# STATE OF VERMONT
# AGENCY OF TRANSPORTATION

# PROPOSED IMPROVEMENT
# BRIDGE PROJECT
## TOWN OF BRATTLEBORO
## COUNTY OF WINDHAM

PROJECT DESCRIPTION : THE PROJECT SHALL CONSIST OF THE REHABILITATION OF BRIDGE NO.7 ALONG WITH RELATED ROADWAY APPROACH WORK.

### RECORD PLANS

# STREET LIGHTING LAYOUT

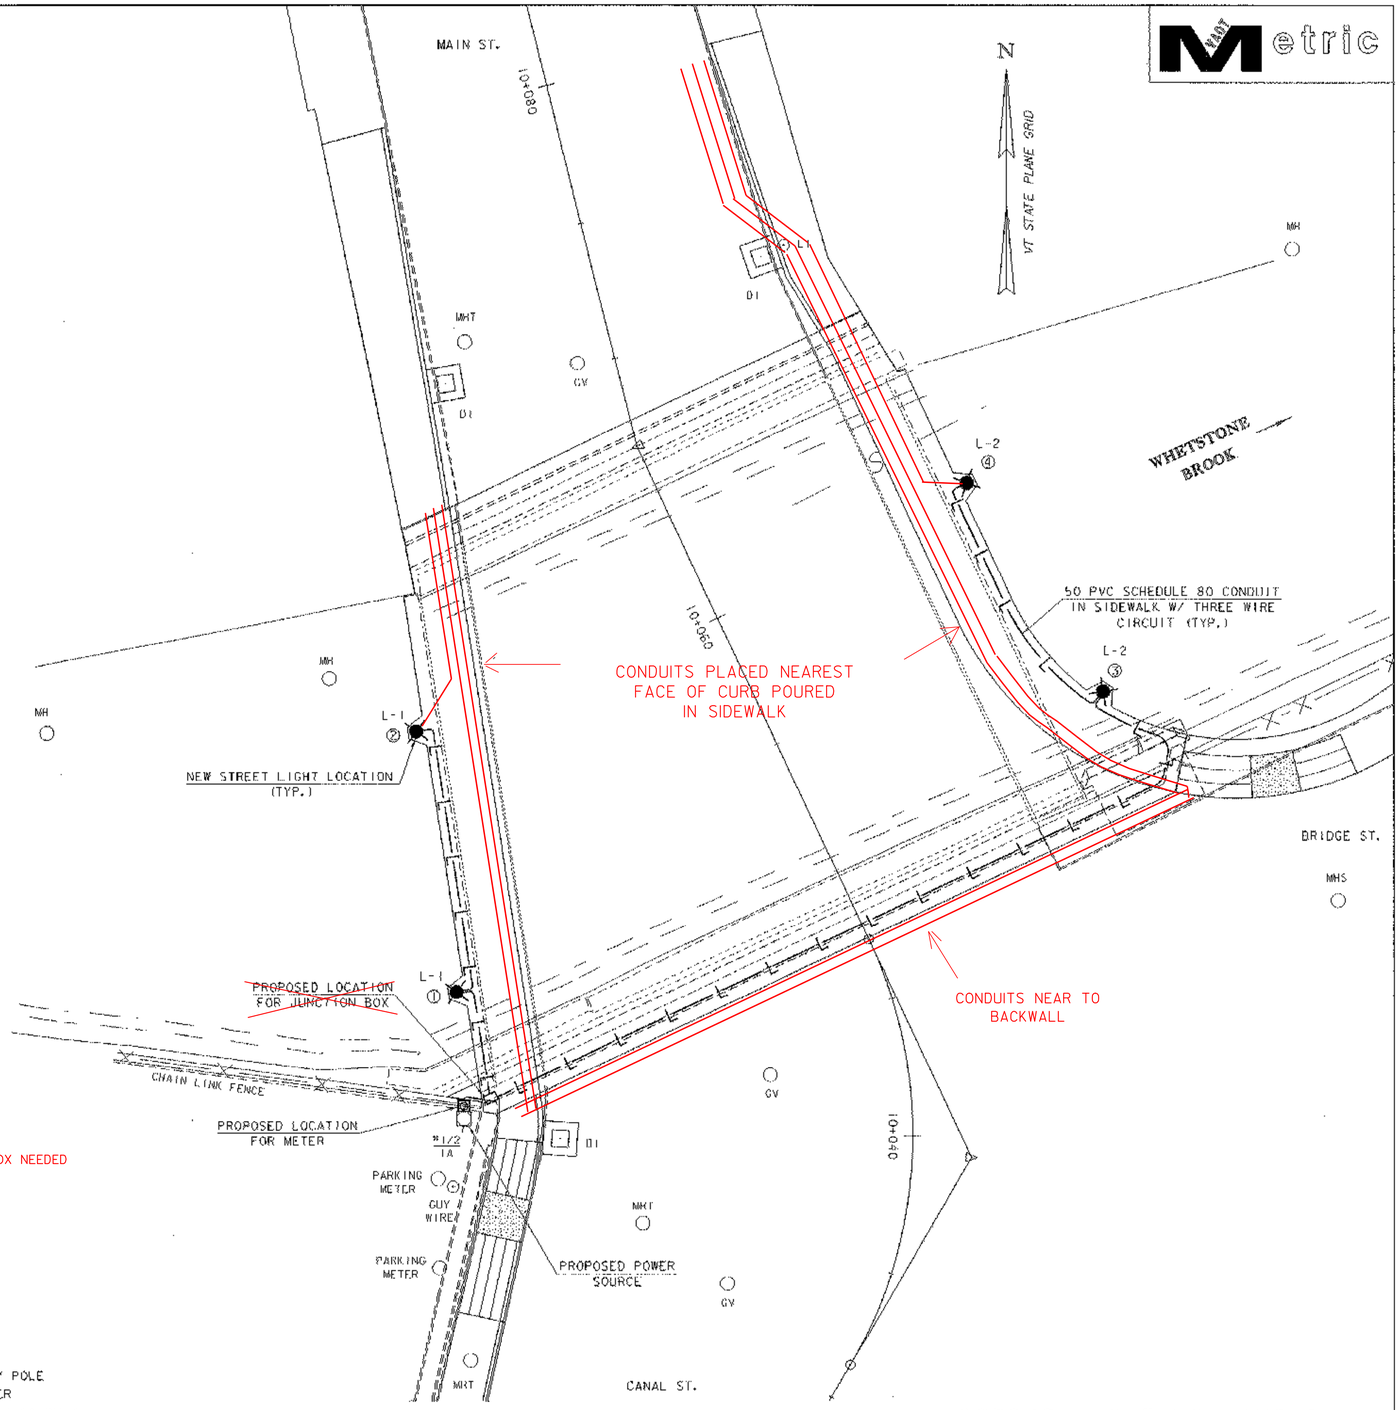
3. INSTALL ALL ~~JUNCTION BOXES~~, THE CONDUIT, PHOTOCELL AND WIRING AS DETAILED ON PLAN DRAWINGS. NO JUNCTION BOX NEEDED

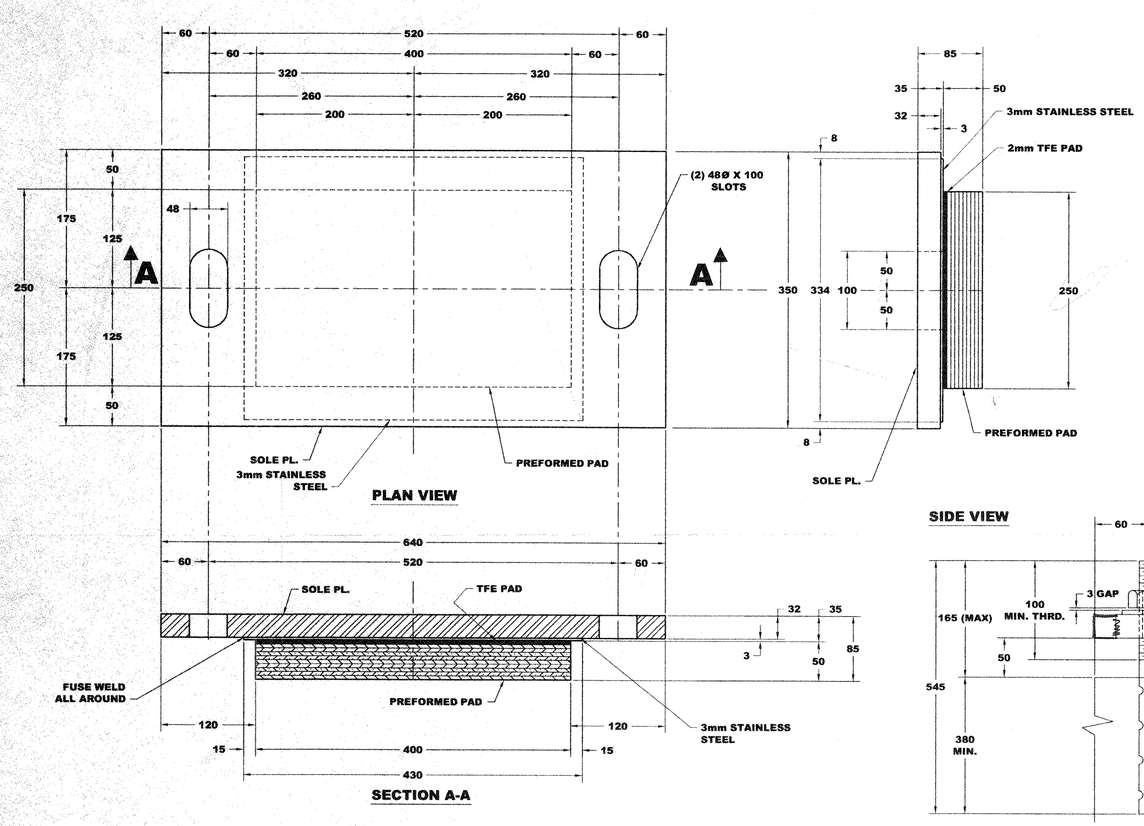
Add same notes as sheet 1.

# EXPANSION BEARING DETAIL- ABUTMENT NO. 2

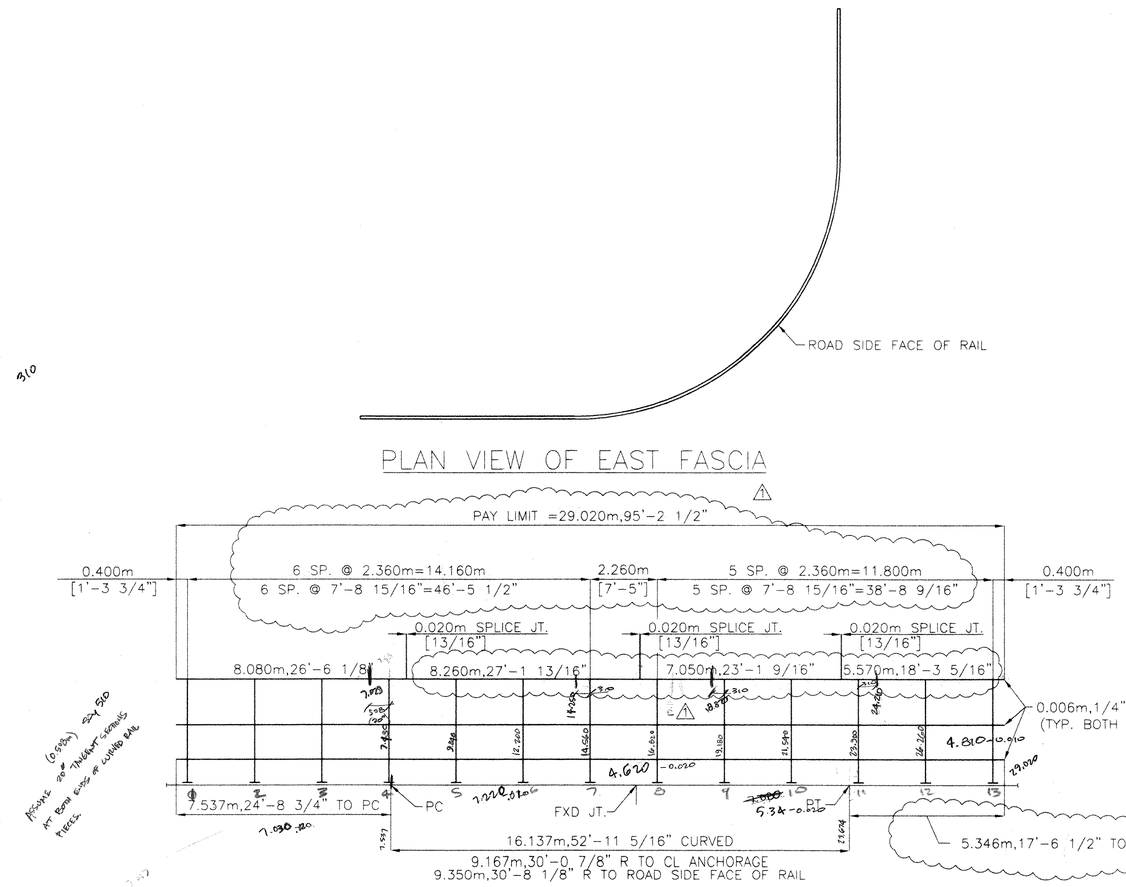
Add same notes as sheet 1 plus: "The surface finish of the contact (sliding) face shall have a mirror finish as per spec. 731.05."

Brattleboro BHF 2000(17)
Sheet # 1

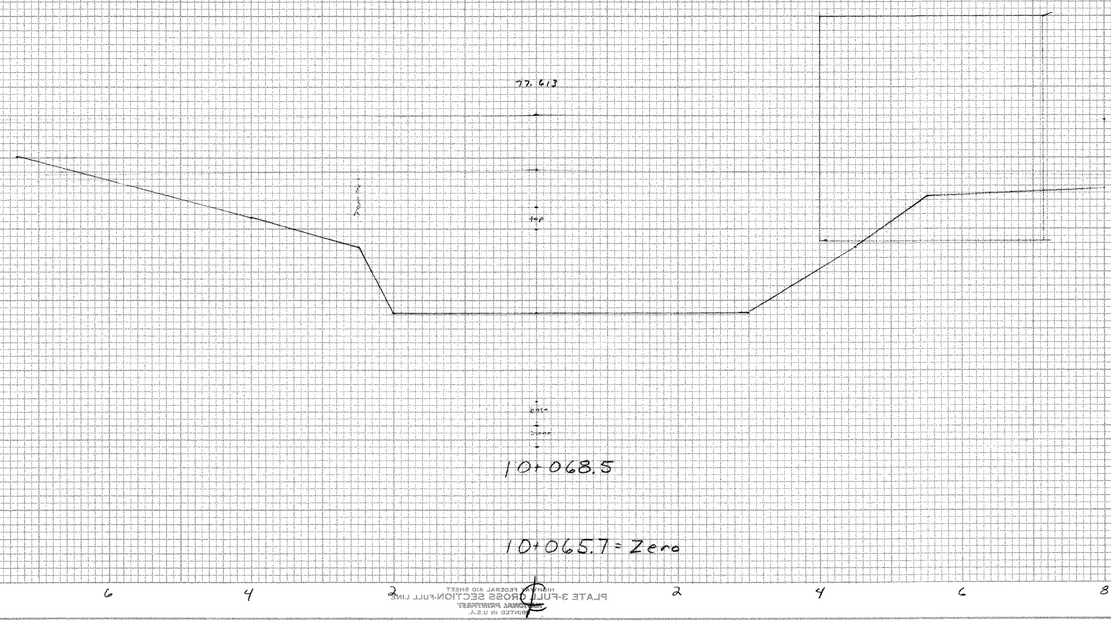
No T.E. for existing 40" + 24" (coming into jet box) - all within Cofferdam limits 12-9-03 ftw

Granular Backfill for Structures
Jet Box 3.04 m wide, 2.43 m long, 3.103 m H
3.04 x 2.43 x 3.103 = 22.92 cm
Cofferdam Earth - volume Jet Box = Gran. bkfill for Structures
59.53 - 22.92 = 36.61 cm 12-9-03 ftw

Culvert right: trench earth minus volume culvert
$\pi r^2$ x length $\pi .225^2 \times 1.9 = 0.30$ cm
4.82 - 0.30 = 4.52 cm 12-9-03 ftw
